Rezoning Transportation Analysis

Petition Number: 2017-121

Date	Description
08-28-2017	First Review

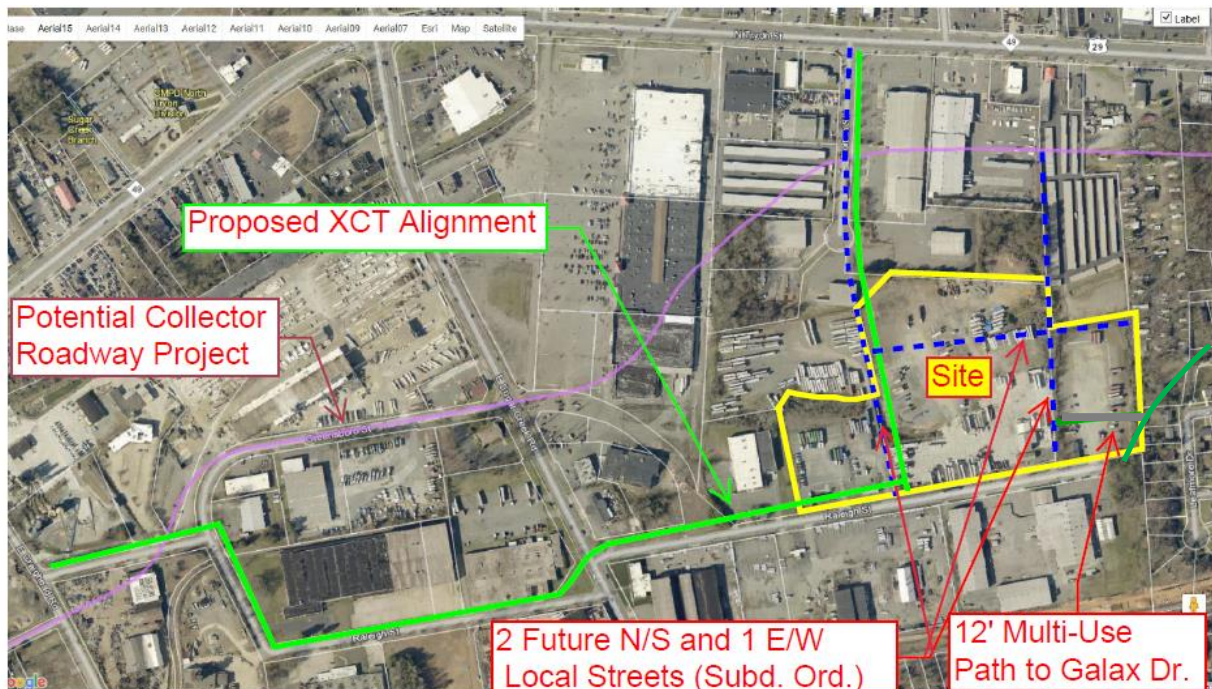
1. **Curblin** The proposed zoning district has a setback measured from back of the existing or proposed future curblin.
 - a. Raleigh
 - i. Western site boundary to N/S Street 1 - The location of future back of curb is 20.5' as measured for the street's existing centerline to accommodate a 10' travel lane and an 8' buffered bike lane. Should the petitioner desire on-street public parking along the site's frontage the above back of curb location will need to be increased by 5'.
 - ii. East of N/S Street 1 - The location of future back of curb is 17.5' as measured for the street's existing centerline to accommodate a 10' travel lane and an 5' bike lane. The

petitioner may maintain the 20.5' dimension if desired for consistency along Raleigh. (see conceptual street/multi-use/bike lane network below). Should the petitioner desire on-street public parking along the site's frontage the above back of curb location will need to be increased by 5'.

- b. N/S Street 1 (westernmost, aligned toward Dorton) - The location of future back of curb is 20.5' as measured for the street's existing centerline to accommodate a 10' travel lane and an 8' buffered bike lane. Should the petitioner desire on-street public parking along the site's frontage the above back of curb location will need to be increased by 5'.

- ~~2. **Traffic Study** A Traffic Impact Study/Transportation Technical Memorandum is not need for the complete review of this petition.~~
3. The petitioner should revise the site plan and conditional note(s) to show the N/S Street 1 aligned toward Dorton St and the E/W Street aligned toward Curtiswood Dr. (see conceptual street/multi-use/bike lane network below) and Greensboro. CDOT understands that two (2) N/S and one (1) E/W local commercial/office street will be required. (see conceptual street/multi-use/bike lane network below)

4. The petitioner should revise the site plan and conditional note(s) to show construction of a 16' shared use path on the north side of Raleigh turning onto the east side of the N/S Street 1 to accommodate the pedestrian portion of the Cross Charlotte Trail (XCLT) alignment. A raised crossing across the westernmost N/S street leg at Raleigh intersection is desired. The in-street buffered bike lanes serve the bicycle portion of the XCLT alignment. (see conceptual street/multi-use/bike lane network below)

5. The petitioner should remove conditional note 2b and revise conditional note 5 since XCLT alignment is defined through this section.
6. The petitioner should revise the site plan and conditional note(s) to provide a 12' wide multi-use path connecting Raleigh St. bike lanes the site's eastern property line aligning with Galax Dr. CDOT requests the petitioner contact the adjacent property owner and attempt to provide the connection to Galax. (see conceptual street/multi-use/bike lane network below)
